Re: Onondaga Lake Capping, Dredging, Habitat and Profundal Zone (SMU 8) Final Design, Modified Protective Cap RA-C2 Design Revision, Dated May 2016

**ONONDAGA LAKE CAPPING, DREDGING,
HABITAT AND PROFUNDAL ZONE (SMU 8)
FINAL DESIGN**

**MODIFIED PROTECTIVE CAP RA-C-2
DESIGN REVISION**

SUMMARY OF DESIGN REVISION

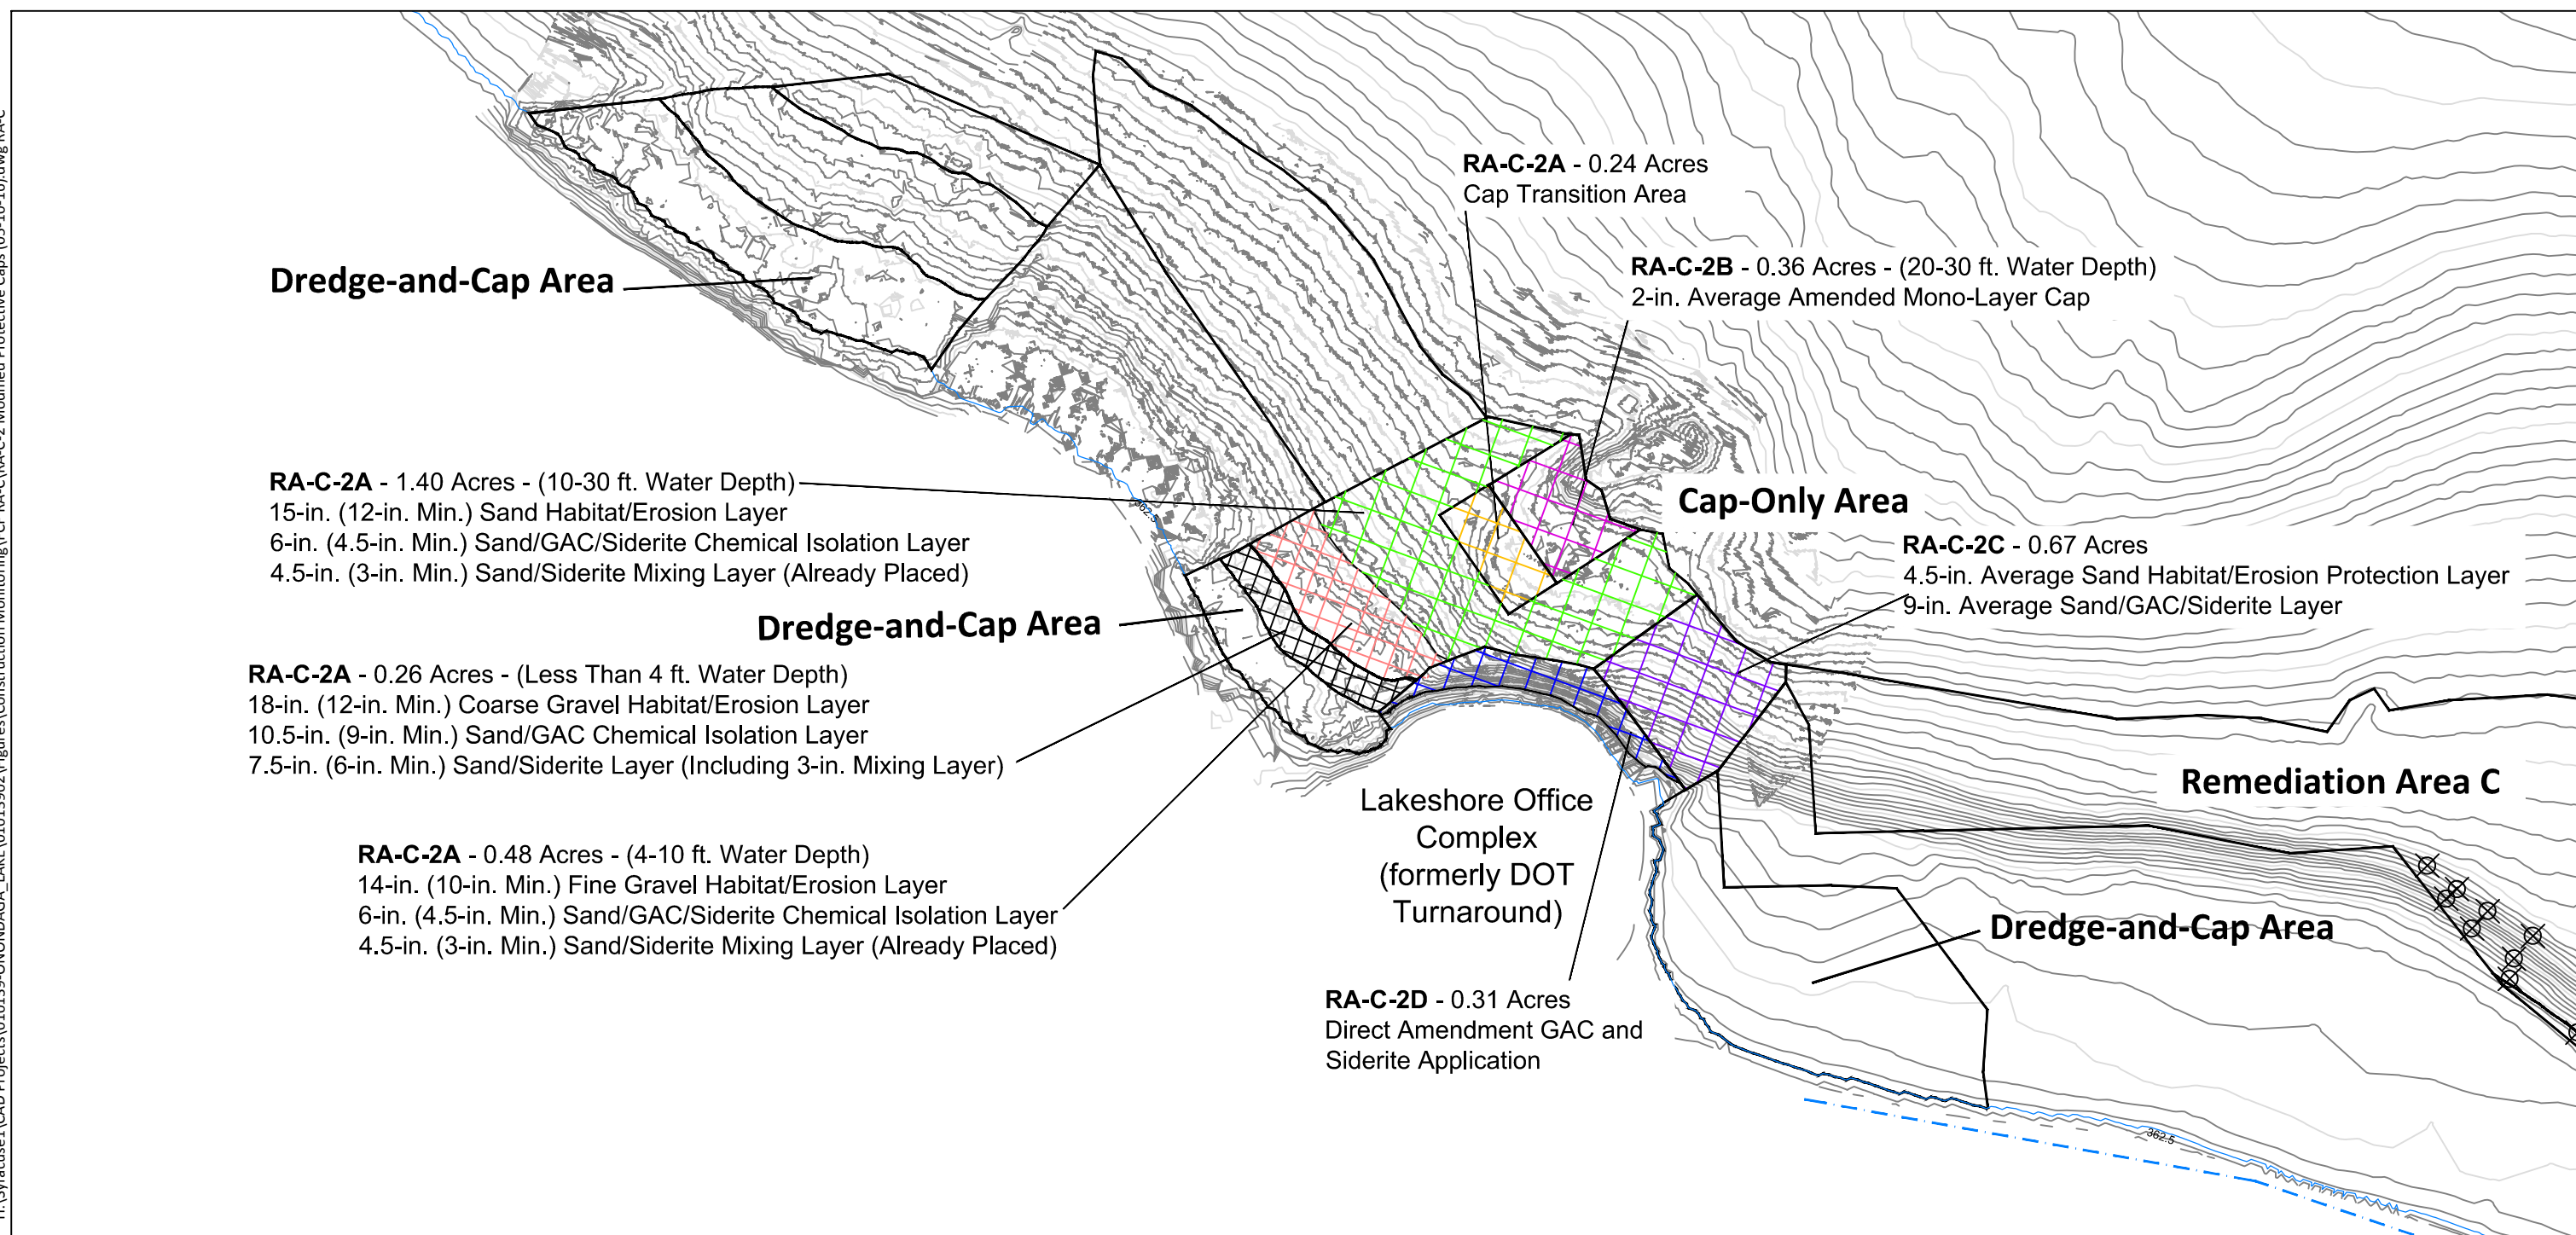
The MPC designs shown in Figure 1 were determined to be stable based on substantial geotechnical data collected in this area subsequent to the Final Design and detailed geotechnical analysis, as presented in Attachment 1. This analysis incorporates the results from field investigations performed with equipment that is both more accurate than that used during the 2005 to 2008 pre-design investigation (PDI) and capable of assessing conditions in the deeper water portions of the lake where softer sediments have been identified. This included cone penetrometer testing (CPT), full flow penetrometer (FFP), and additional vane shear testing (VST). In addition to the improved accuracy of these measurements, the use of these methods in areas of the site with previously placed cap materials has allowed an assessment of cap placement induced strength gain (from consolidation) in the sediment, which has been a key consideration in the slope stability assessments in some cap areas.

The MPC designs were optimized to maximize the total thickness of the cap while still meeting the required factor of safety based on geotechnical considerations. The thickness and composition of the various layers comprising the MPCs are shown below as well as on Figure 1. Chemical isolation modeling was completed to determine the granular activated carbon (GAC) application rates that will result in MPCs that are protective for isolation of organic contaminants for at least 1000 years, consistent with the evaluation timeframe used in the Final Design, as documented in Attachment 2. Modeling also verified that the MPCs will be protective for isolation of mercury for at least 1000 years; the minor exception to this may be portions of the small direct amendment application area, as discussed below following the bullets. The thickness and composition of the various layers comprising the MPCs, including the updated GAC application rates based on the modeling, are listed below.

RA-C-2A (less than 4 feet) (Multi-layer Cap) - GAC application rate of 0.1 lbs/sf

- 12-inch minimum coarse gravel habitat/erosion protection layer
- 9-inch minimum sand/GAC chemical isolation layer
- 3-inch minimum of sand/siderite chemical isolation layer
- 3-inch minimum of sand/siderite mixing layer

RA-C-2A (4 to 10 feet) (Multi-layer Cap) - GAC application rate of 0.1 lbs/sf

- 10-inch minimum fine gravel habitat/erosion protection layer
- 4.5-inch minimum sand/GAC/siderite chemical isolation layer
- 3-inch minimum of sand/siderite mixing layer

RA-C-2A (10 to 30 feet): (Multi-layer Cap) - GAC application rate of 0.1 lbs/sf

- 12-inch minimum sand habitat/erosion protection layer
- 4.5-inch minimum sand/GAC/siderite chemical isolation layer
- 3-inch minimum sand/siderite mixing layer

RA-C-2A Cap Transition Area - GAC application rate of 0.1 lbs/sf

- One to four layers as the cap transitions between RA-C-2A and RA-C-2B, as shown in Attachment 1. Where present, the layers within the transition zone will be consistent with the layers within adjacent RA-C-2A.

RA-C-2B (20 to 30 feet) (Mono-layer Cap) - GAC application rate of 0.1 lbs/sf

- 2-inch average sand/GAC/siderite

RA-C-2C: (Multi-layer Cap Conservatively Modeled as Mono-Layer Cap) - GAC application rate of 0.1 lbs/sf

- 4.5-inch average sand habitat/erosion protection layer
- 9-inch average sand/siderite/GAC layer

RA-C-2D (Direct Amendment Application) - GAC application rate of 0.1 lbs/sf

- GAC and siderite direct application. Will include a volume of sand during placement approximately equal to 0.5 inches to facilitate placement

Figure 8. Recommended cap placement in modified protective cap area RA-C-2.

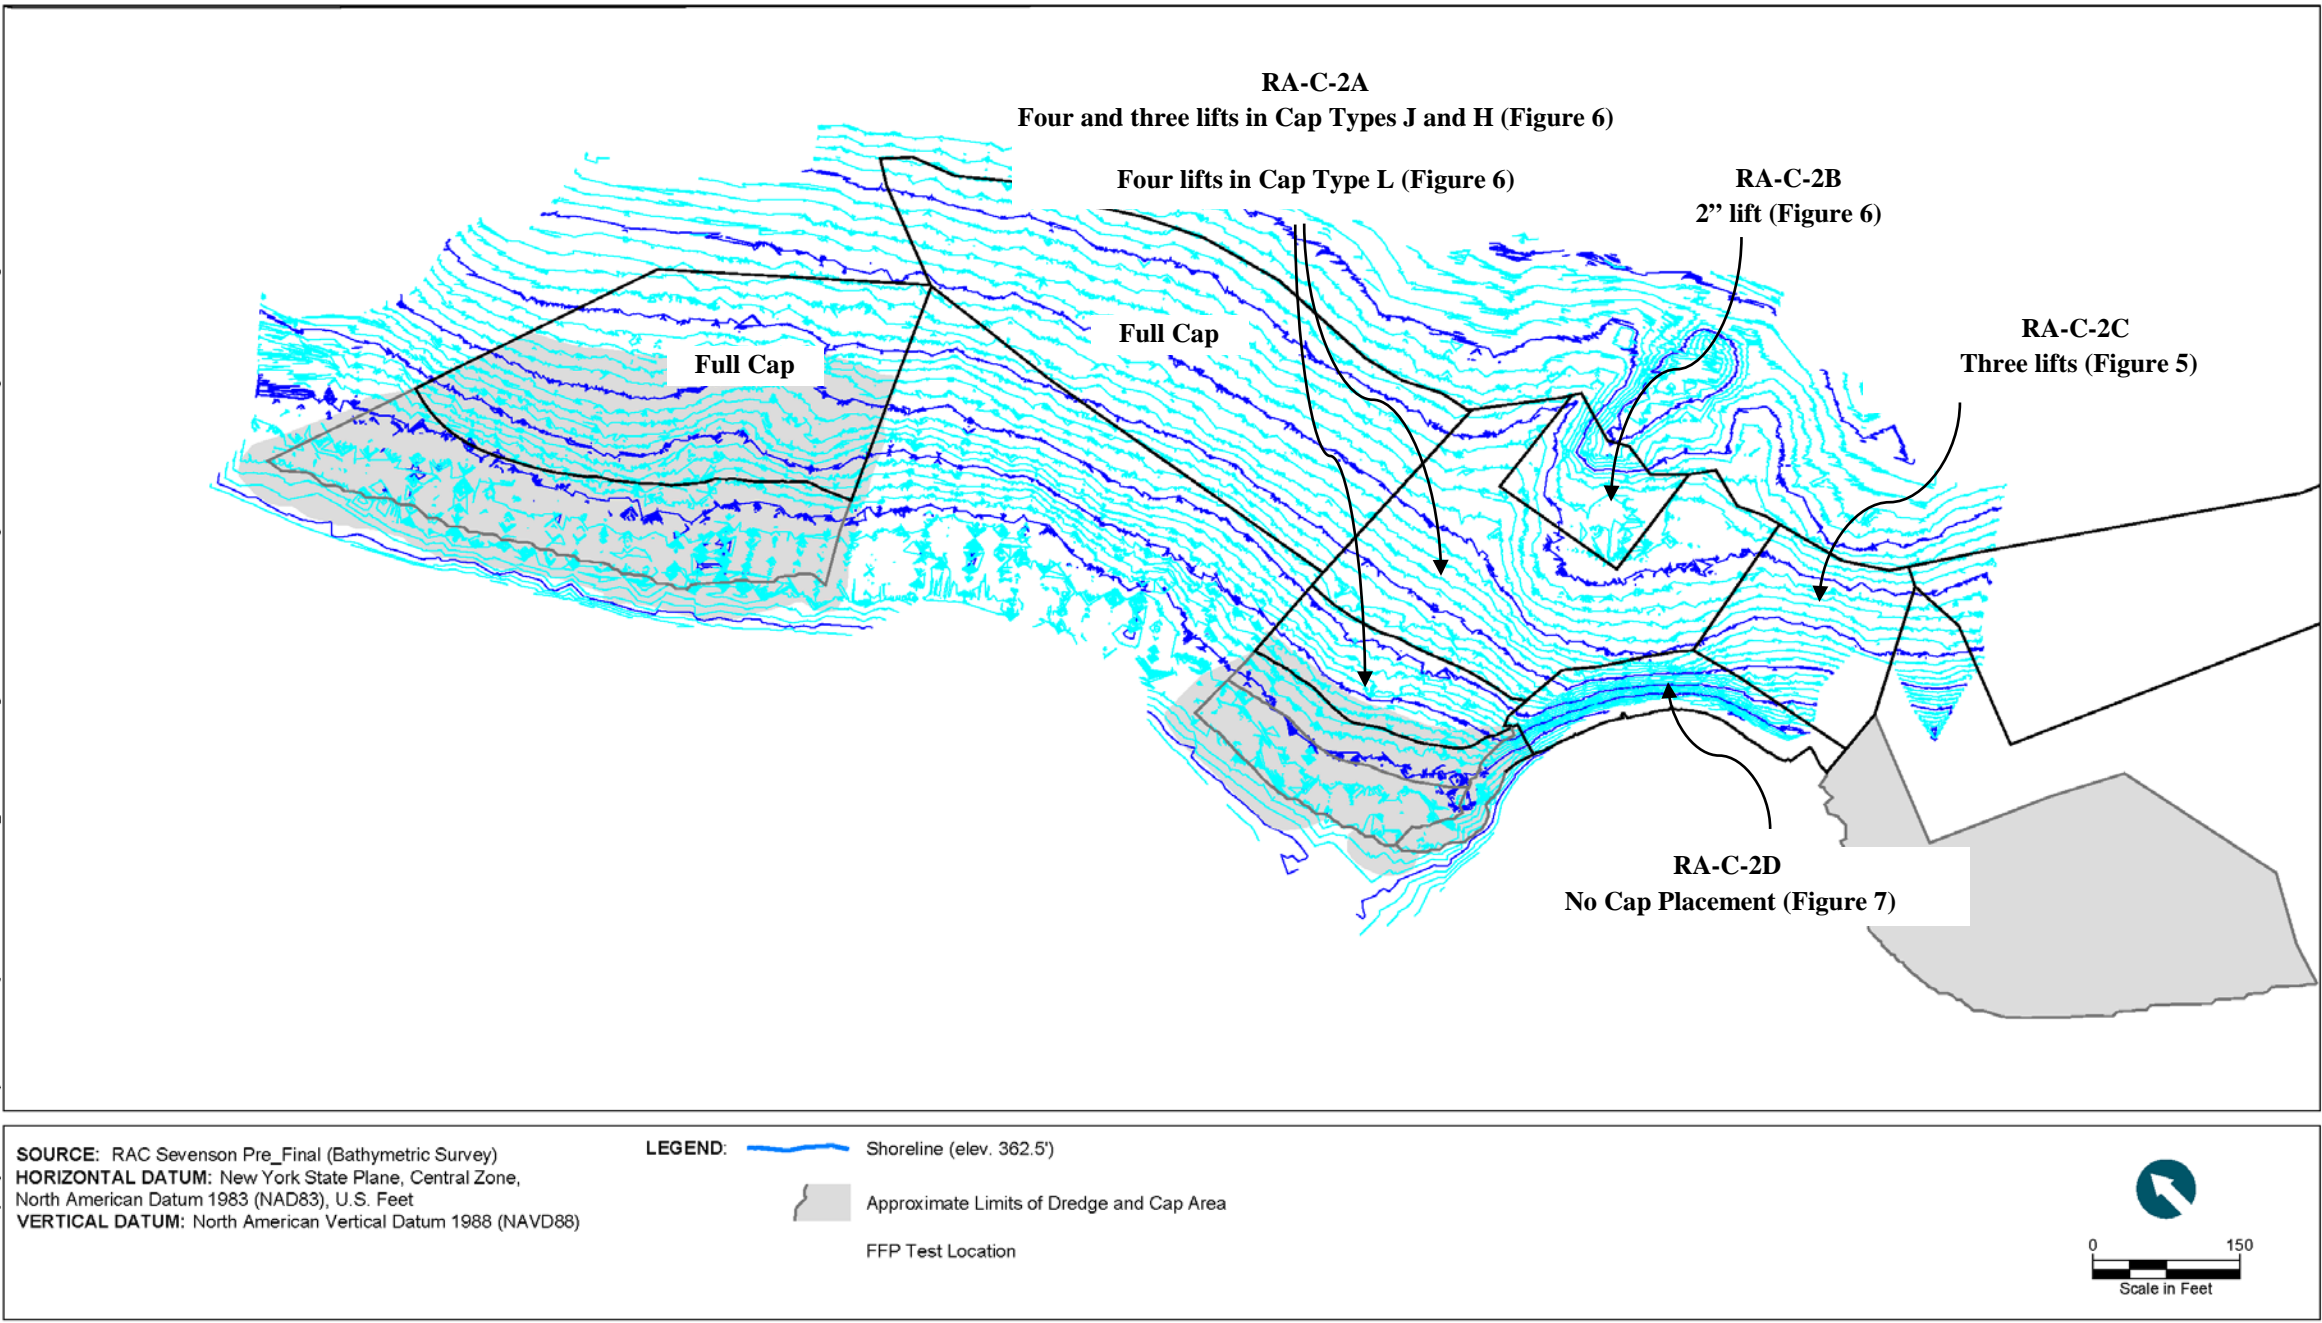
Figure 8 shows the recommendation for cap placement in the modified protective cap area RA-C-2.
